To: T10 SAS Protocol and Phy Working Groups
From: Brian Day and William Petty
Subject: SAS-2.1 / SPL: 08-439 An Optical OOB Method

Overview

Figure 1 — OOB signal transmission

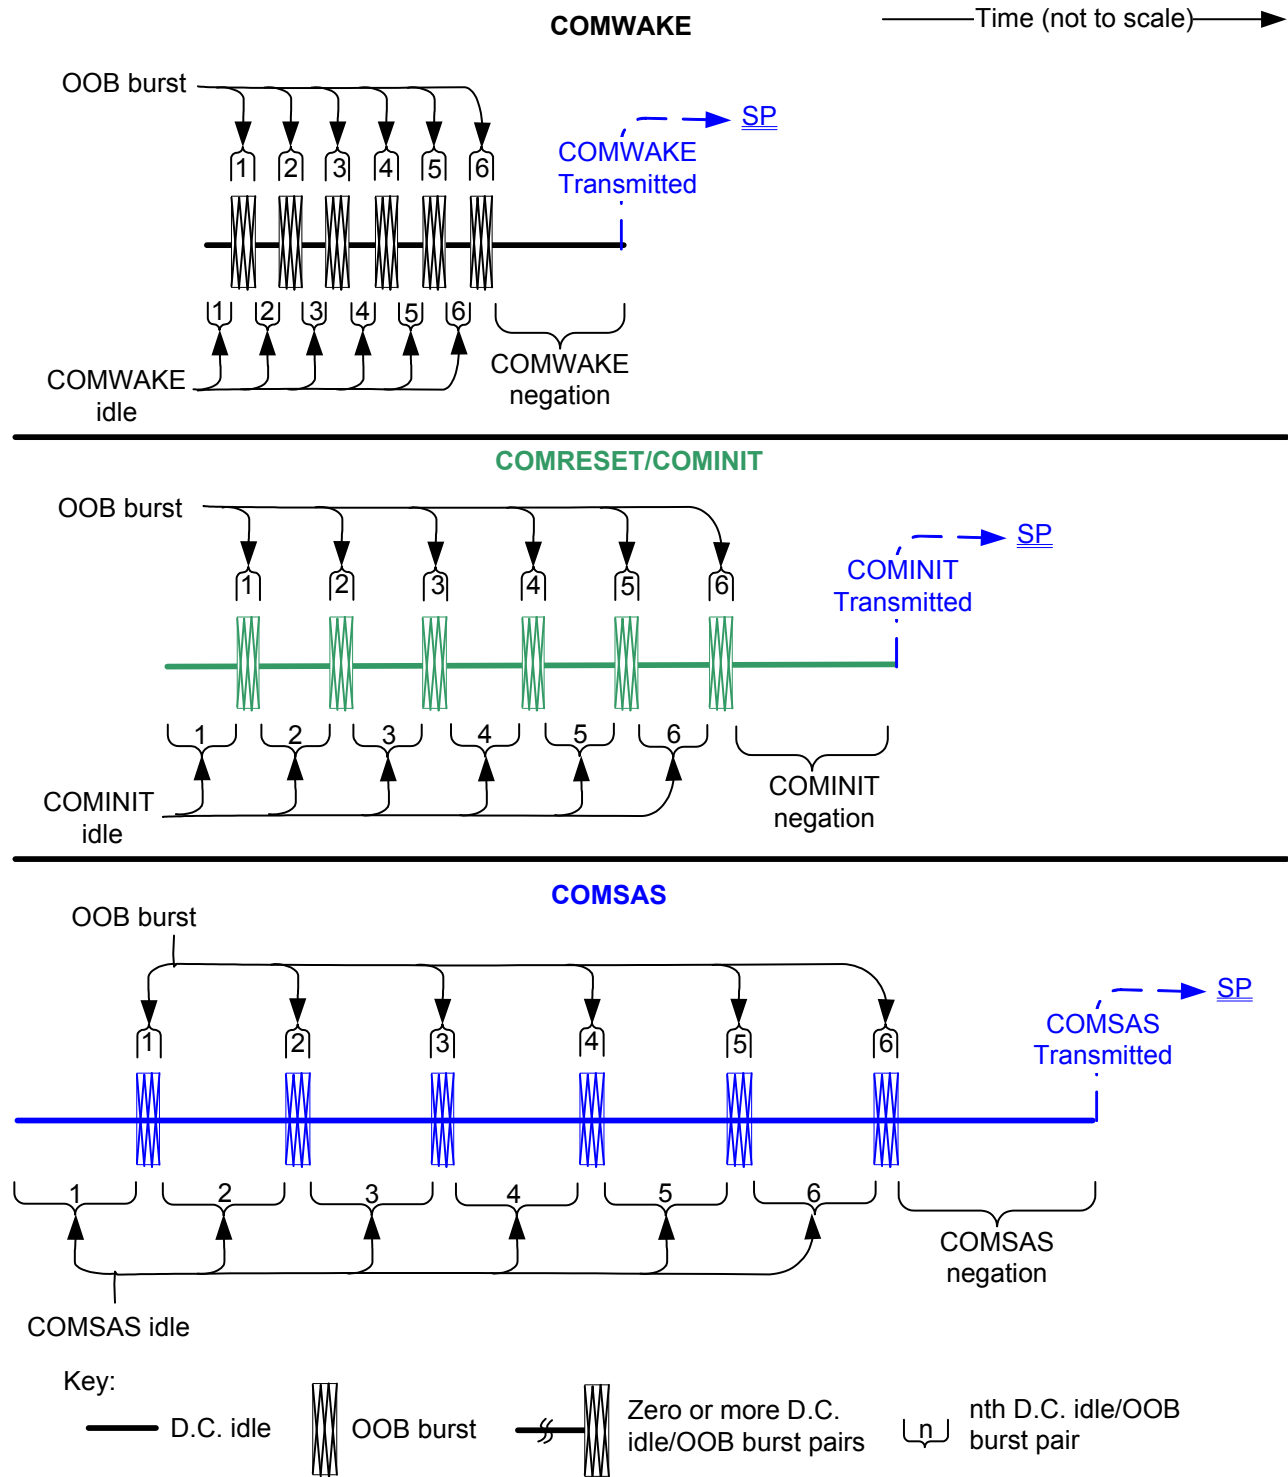
Editor's Note 1: [All figures in section 6 need to replace "D.C. Idle" with "OOB Idle"](#).

If D.C. mode is enabled, an OOB idle consists of the transmission of D.C. idle.

If optical mode is enabled, an OOB idle consists of repetitions of the following steps:

- 1) transmission of six OOB_IDLE primitives with either starting disparity at 3.0 Gbps; and
- 2) transmission of up to 1 024 dwords set to 00000000h that are transmitted scrambled and 8b10b encoded at 3.0 Gbps.

An OOB burst consists of:

- a) if D.C. mode is enabled, transmission of D24.3 characters or ALIGN (0) primitives with either starting disparity. The OOB burst should consist of D24.3 characters at 1.5 Gbps; or
- b) if optical mode is enabled, transmission of ALIGN (3) primitives with either starting disparity at 3.0 Gbps.

Figure 2 — OOB signal detection

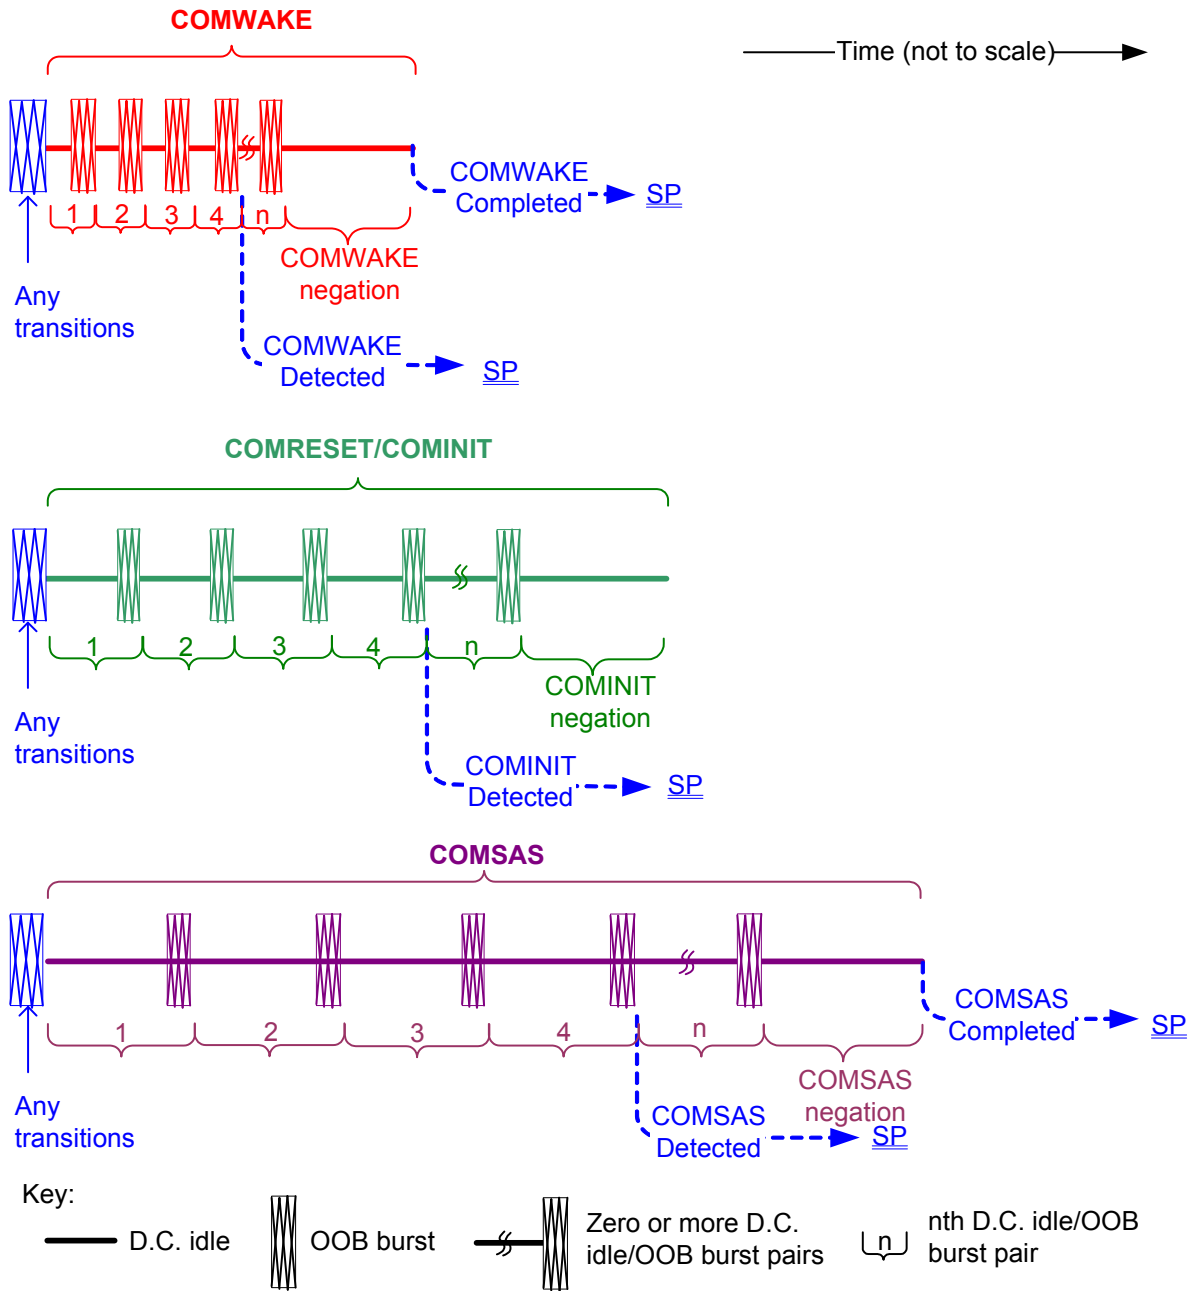
Editor's Note 2: Throughout section 6.7 and 6.8, replace all references of "D.C. idle" with "OOB idle" for the idle times to transmit OOB signals. Change all references of "D.C. idle" with "negation idle" for the idle time during the speed negotiation window during the RCDT.

When optical mode is enabled, a SAS receiver device shall detect OOB bursts formed from ALIGN(3) primitives at 3Gbps.
